Project Name : JSL GLOBAL QFZ LLC
GLOBAL TRANSPORT SOLUTIONS, FREIGHT FORWARDING

TS Reference Nr. : QFZ-PMT-QDC-TN-2021-0298

Subject : CLIENT: JSL GLOBAL QFZ LLC/ CONSULTANT: QATAR DESIGN CONSORTIUM W.L.L. / LIGHT INDUSTRIAL UNIT LG-22-23 UNIT 2-3/ LOCATION: UMM AL HOUL FREE ZONE/ DC2 - TELECOM/CCTV DRAWINGS RE-SUBMISSION

Contents : Attached Design Review Sheet Ref. Nr. 2826-LG-022023(UNIT2-3)-DRS-TELE-QFZ-0009 Review Round Nr. 04

Comment on Transmittal 2826-LG-022023(UNIT2-3)-DRS-TELE-QFZ-0006

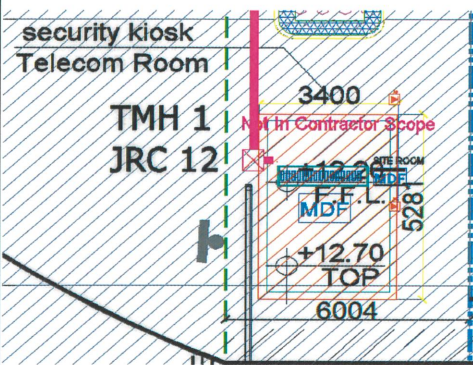
- 4- Kindly add existing ooredoo network
- 2- the previous comment no. 2 is still valid , kindly provide different hatch for the location of the service provider room)

- 3- the previous comment no. 3 is still valid , kindly add ooredoo notes as indicated.
- 5- Kindly add coordinates for site boundary .

- 2-closed
- 3-closed
- 5-closed
- Kindly add existing ooredoo network

- 4-closed

- 2- Noted and Complied. The service provider room has been provided with a different hatch (magenta) and clouded. Please refer to the revised layout.
- 3- Kindly note that, the Ooredoo notes has already been added and shown on the previous submission. Cloud is added on the revised layout for easy reference.
- 4- Noted and Complied. Coordinates for site boundary are provided.

- 4- Kindly note that existing Ooredoo network has already shown on the Dwg# 3641-ET-B0-G-001 SITE PLAN,

As per the Legends provided in the drawing, All structures and equipment under the hatch area are indicated as existing.
